Viridor South London Limited

Beddington ERF and WTS

Response to additional queries

Figure 1: Firing diagram

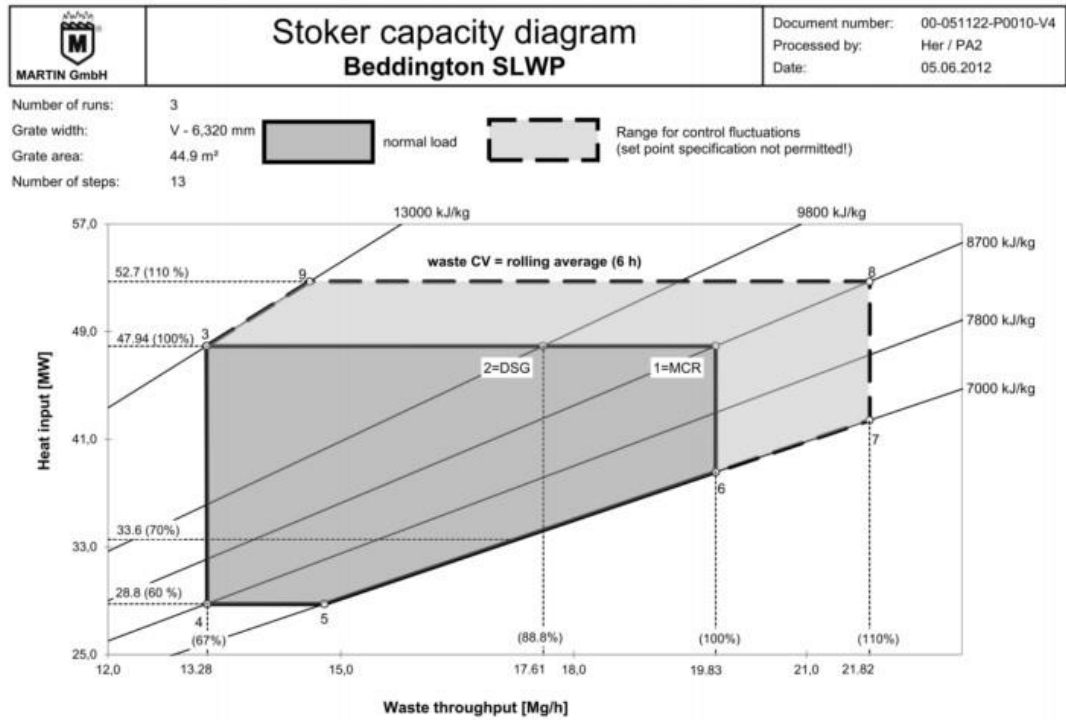
- You have not demonstrated how the throughput capacity at the tipping hall is sufficient. You have only mentioned that a buffer was built into the design of the tipping hall, but have not provided any figures to demonstrate this.
- You have not demonstrated how the throughput capacity within the bunker is sufficient, only that buffer storage capacity was designed into the bunker, but no specific figures on capacities has been provided.
- You have not demonstrated how the emissions abatement equipment is sufficiently sized, only that an operational buffer has been designed into the equipment, but no specific figures on the designed treatment/flow rates.

For the above you need to demonstrate that each stage of the process is sufficiently sized. For example this could be shown through the original design calculations/specifications for that process/piece of equipment.

The maximum annual throughput proposed within the application is a theoretical maximum derived from the top right-hand corner of the firing diagram (the 110% point – refer to Figure 1). The maximum annual throughput allows contingency in the future operation of the ERF, for example the average NCV of waste continuing to drop over time. The maximum annual throughput proposed within the application also allows for an increased availability, to allow flexibility in maintenance periods being scheduled e.g. every 18 months. It should be acknowledged that the ERF may not operate at the 110% point all the time.

The ERF has been designed and is operated to accommodate all operating scenarios under the firing diagram. This is explained/demonstrated in further detail below, in relation to the specific points raised by the EA.
